Title	C-GROK - Battery / Alternator			
Author	Les Kearney			
File	H:\RV10\GROK\Electrical\Wiring\ESysv81.vsd			
Version	8.1	Date	2023 Nov 24	1-Pwr

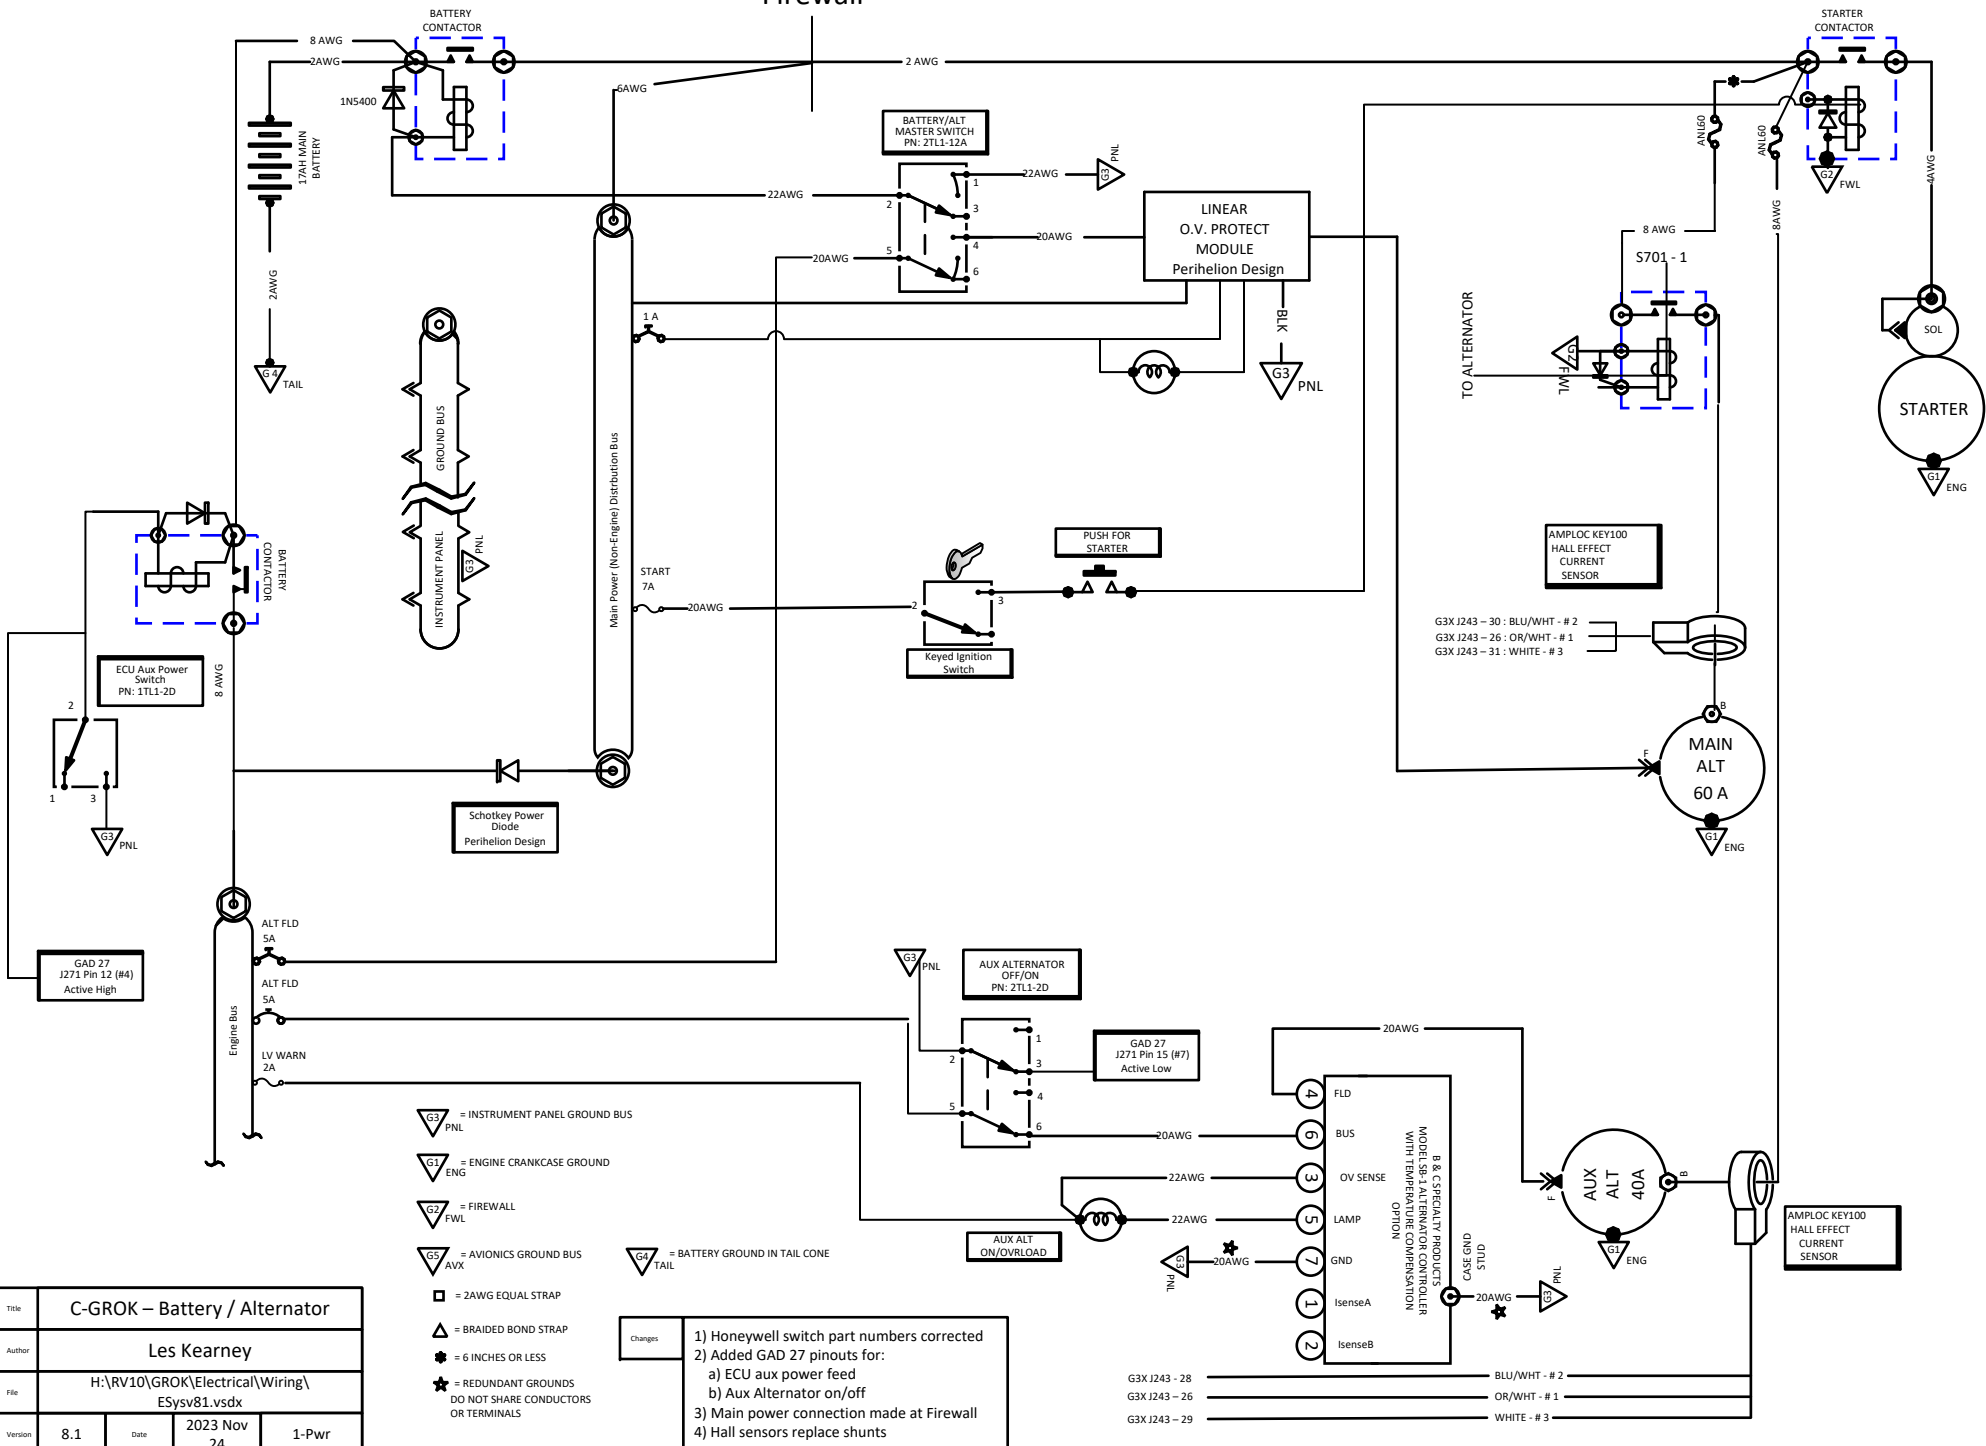
- 1) Honeywell switch part numbers corrected
- 2) Added GAD 27 pinouts for:
 - a) ECU aux power feed
 - b) Aux Alternator on/off
- 3) Main power connection made at Firewall
- 4) Hall sensors replace shunts
